ECE/TRANS/WP.29/2008/98
24 July 2008

Proposal for Supplement 3 to the 03 Series of Amendments to Regulation No. 107
(M₂ and M₃ vehicles)

Submitted by the Working Party on General Safety Provisions */

Figure A

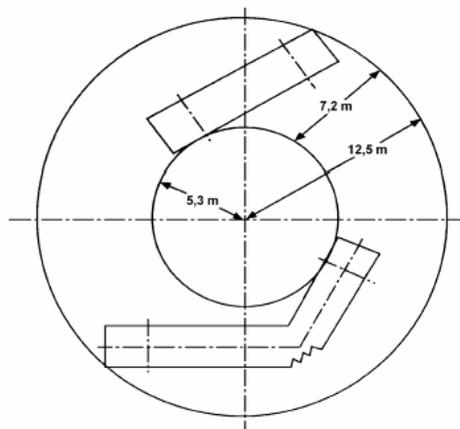
3.4.1.1. The requirements of paragraph 3.4.1. shall be verified with the outermost front point of the vehicle guided along the contour of the outer circle (see figure A).

Figure B

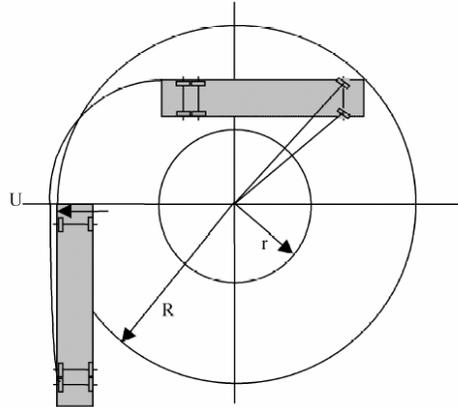
3.4.2. With the vehicle stationary, a vertical plane tangential to the side of the vehicle and facing outwards from the circle shall be established by marking a line on the ground. In the case of an articulated vehicle, the two rigid portions shall be aligned with the plane. When the vehicle moves from a straight line approach into the circular area described in paragraph 3.4.1., no part of it shall move outside of that vertical plane by more than 0,60 m (see figures B and C).
